Customer Bulletin

Rotaries #14-65

Safety Rework—Cutting Deck Latch Replacement

Groundsmaster 3200, 3300, and 3310 Cutting Unit

Figure 1

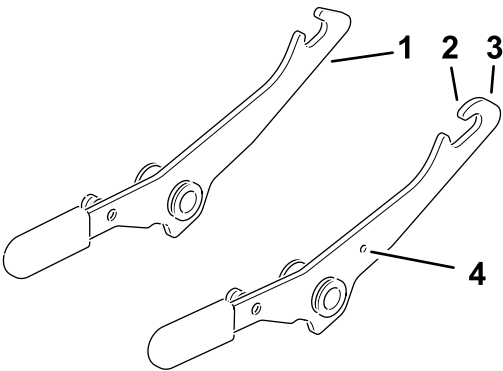
The cutting-unit service latch will not retain a vertical position if the cutting-unit lift arms become lowered.

Replace the existing latch arm with the updated new latch arm (Part No. 147-0066) on all cutting units listed in the rework completion list.

1. Existing latch arm

2. New shape to the hook
3. New latch arm

4. New hole for quick identification

Figure 2

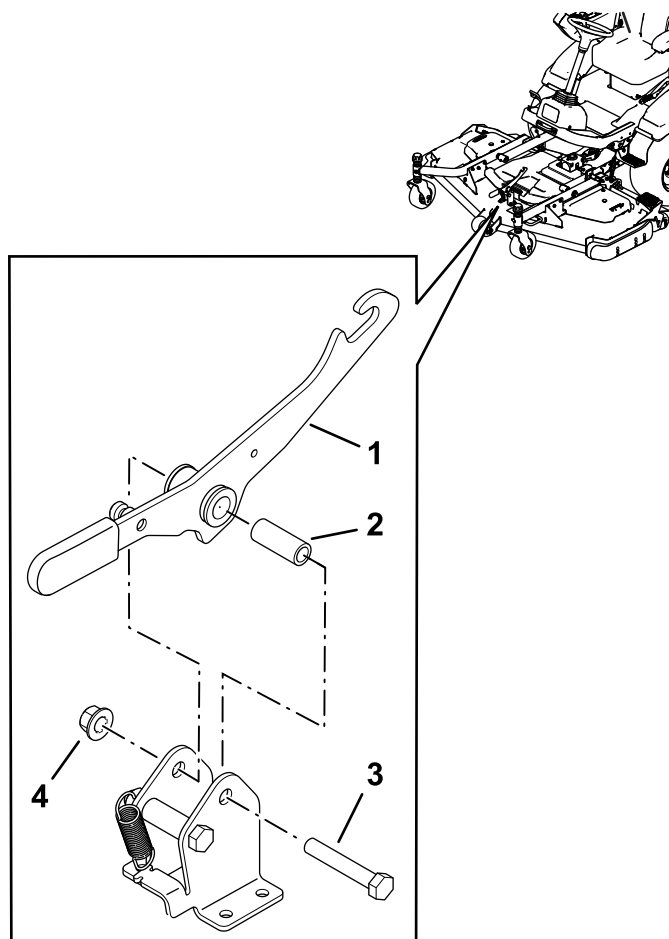
1. Order the new latch arm, Part No. 147-0066; refer to [Figure 2](#).
2. Park the machine on a level surface, engage the parking brake, lower the attachment, shut off the engine, and remove the key.
3. Remove the spring attached to the existing latch arm.
4. Remove the existing latch arm from the machine.
5. Install the new latch arm; refer to [Figure 2](#).

-
6. Install the spring to the new latch.
 7. Raise the mower deck into the maintenance position and lower it to ensure that the issue has been resolved.
